Recall Information Bulletin

No: C1002210 **Issued:** 8/9/2007

Re: 4M50 Idler Gear Shaft Flange

Safety Recall C1002210 - 4M50 Idler Gear Shaft Flange

3. Measurements

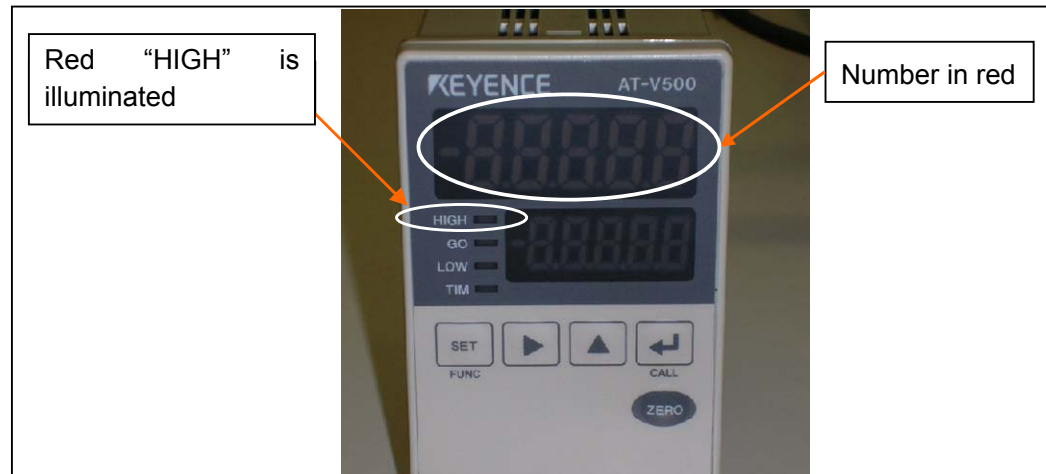
a. I/D of the head idler gear bushing is $\phi 32.043\text{mm}/1.262''$ or below. Number(s) on the measurement display is in green and "GO" is illuminated.

b. I/D of the head idler gear bushing is over $\phi 32.044\text{mm}/1.262''$. Number(s) on the measurement display is in red and "HIGH" is illuminated.

→ OK

→ NG :Replace the cylinder head idler gear, shaft and shaft bolt.

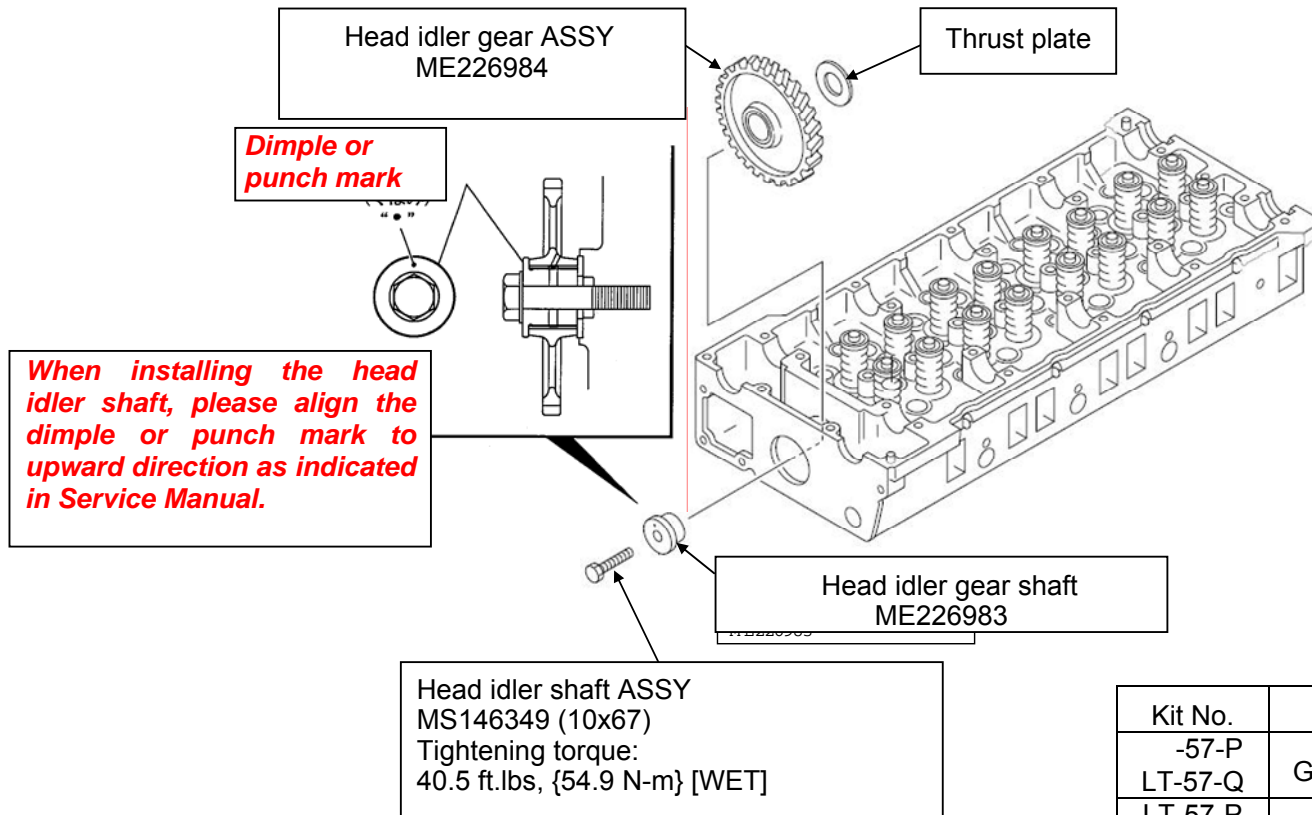
NOTE: When removing the head idler gear, be sure not to drop the thrust plate by pressing it against the cylinder head.

Kit No.	Pat Name	Part No.	Q'ty
-57-P LT-57-Q	GEAR ASSY, IDLER HEAD	ME226984	1
LT-57-P LT-57-Q	SHAFT, IDLER HEAD	ME226983	1
LT-57-P LT-57-Q	BOLT, FLANGE(10X67)	MS146349	1

Description of work	Tightening torque for the head idler shaft bolt
Inspection only (re-use of existing gear)	29.6 ft.lbs, {40.2 N m } [WET]
Replace gears	40.5 ft.lbs, {54.9N m } [WET]

Measuring before removal and reassembling head idler shaft

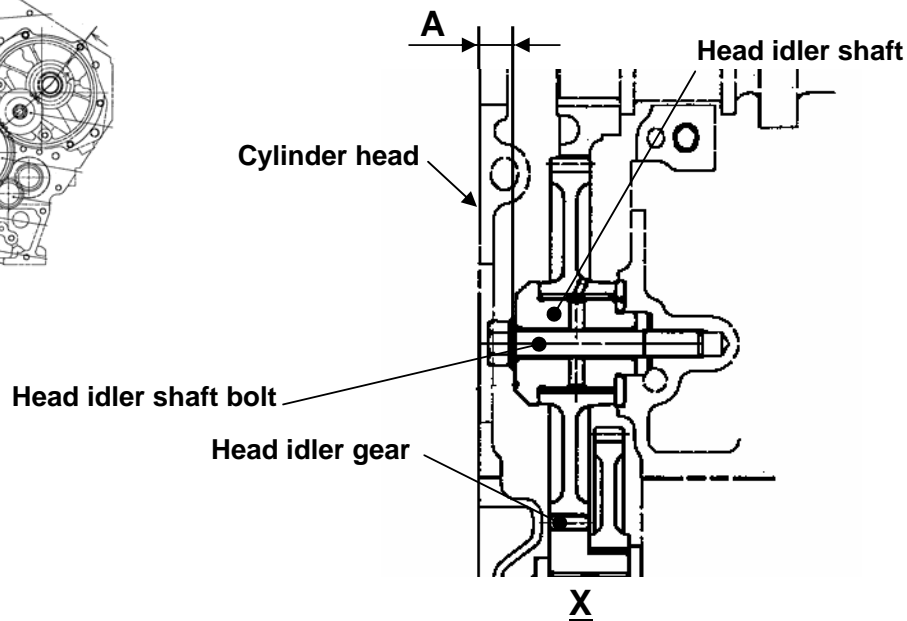
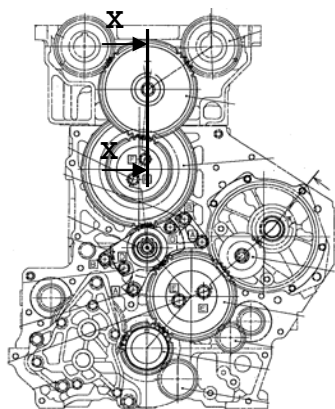
Be sure to measure below distance before removal and reassembling of the head idler shaft

Caution 1: When removing the head idler shaft, measure the distance before loosening the head idler shaft bolt. The head idler shaft may come off due to the affection of valve spring remaining force and this may change the distance.

Caution 2: When reassembling the head idler shaft, measure the distance before tightening the head idler shaft bolt.

Distance "A" : From end surface of a cylinder head to end surface of a head idler shaft

1) Existing head idler shaft (Thin flange): 0.71" (18 mm)

2) New head idler shaft: 0.51" (13mm)
